SUMMARY OF THE 2nd MEETING FOR THE REVISION OF THE GPP CRITERIA FOR WINDOWS AND EXTERNAL DOORS

**25th October 2012,
DG ENVIRONMENT, Brussels, Belgium**

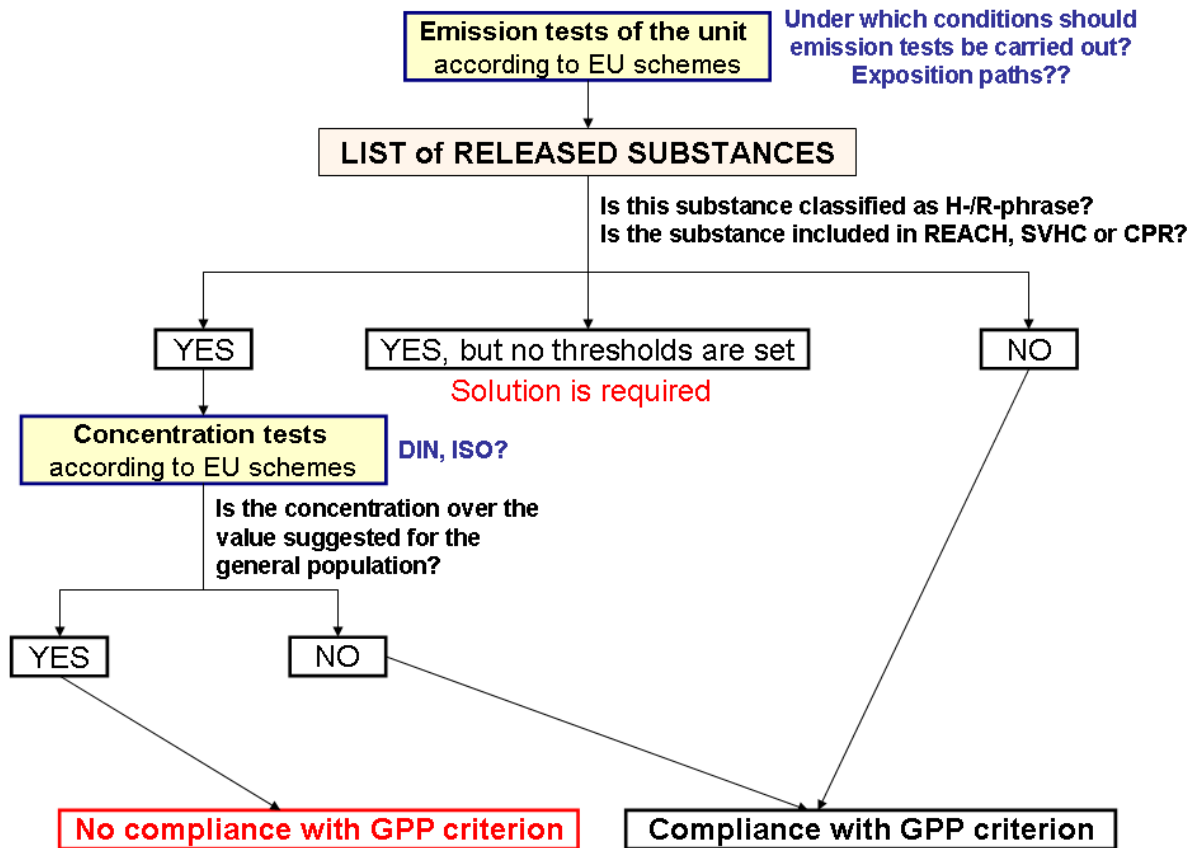
- In order to apply this idea the following decision tree was suggested for further development:

Regarding this decision tree, threshold values for each classified H- and/or R-phrase substances should be included. Currently, these values are only provided in the cases where the mass weight in content of the hazardous substance is above 0.1% in the product.

In addition, several disadvantages were pointed out such as the need of including testings for the release of hazardous substances to the air, water or soil because of the need of covering all the life cycle phases of the product and the mismatches with the schemes that are mainly focused on the indoor air quality.
